Item: 9

DC/24/0773/VOC

Variation of Condition Nos. 4 (materials) and 9a (approved plans for residential development) of DC/23/0539/VOC - Changes to materials for residential units and amendments to approved plans including changes to elevations and revisions to site layout and parking.

Former Deben High School, Garrison Lane, Felixstowe

Other changes to layout

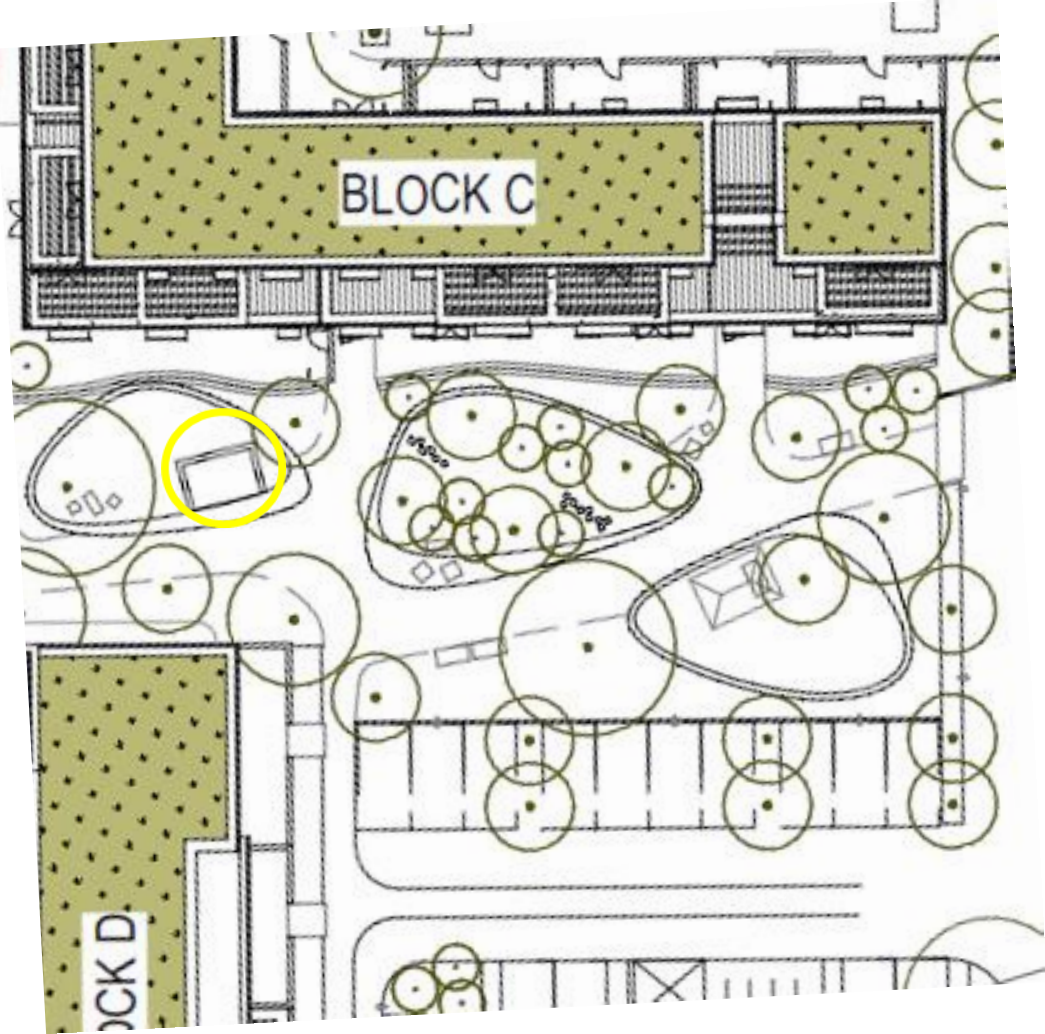
- Cycle store between Blocks C and D relocated further east

Other changes to layout

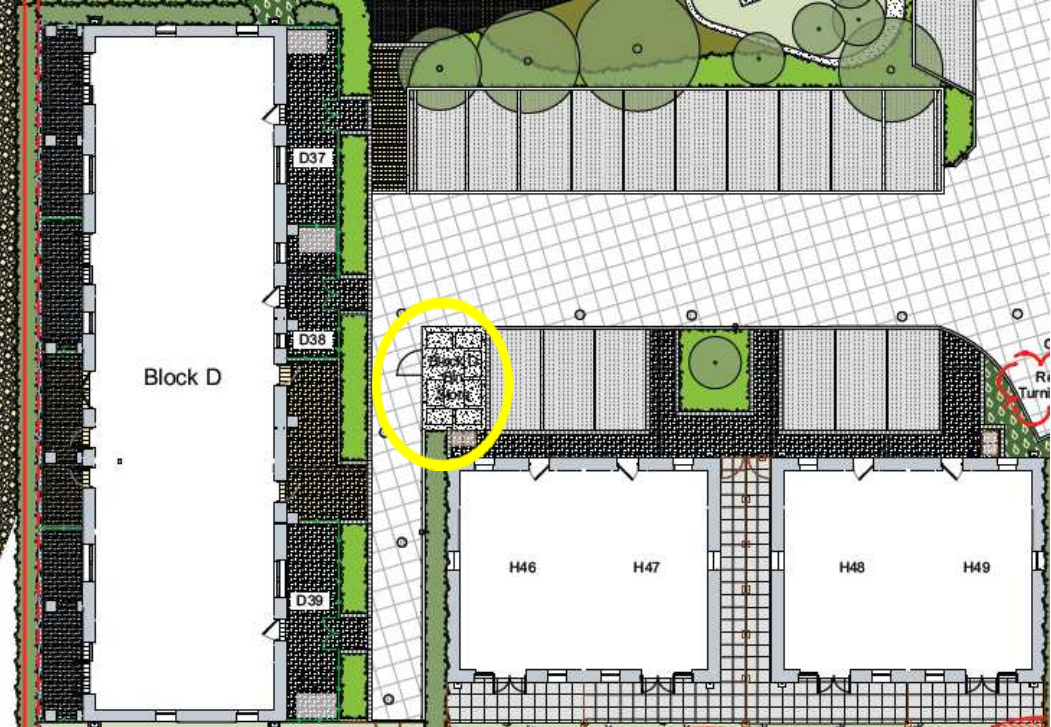
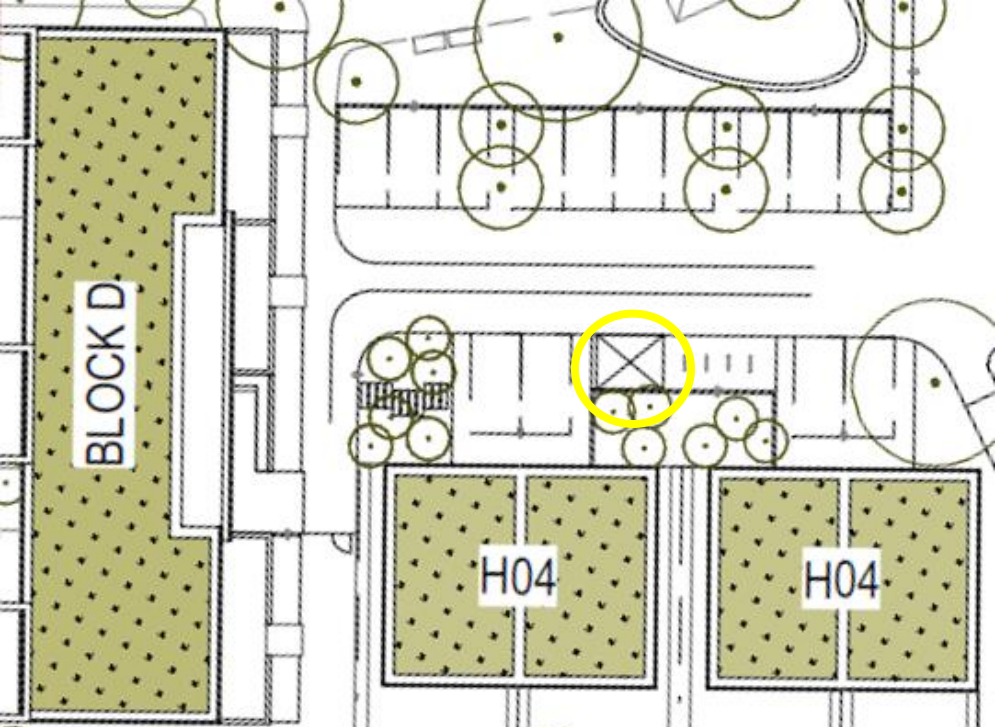
- Bin store for Block D moved closer
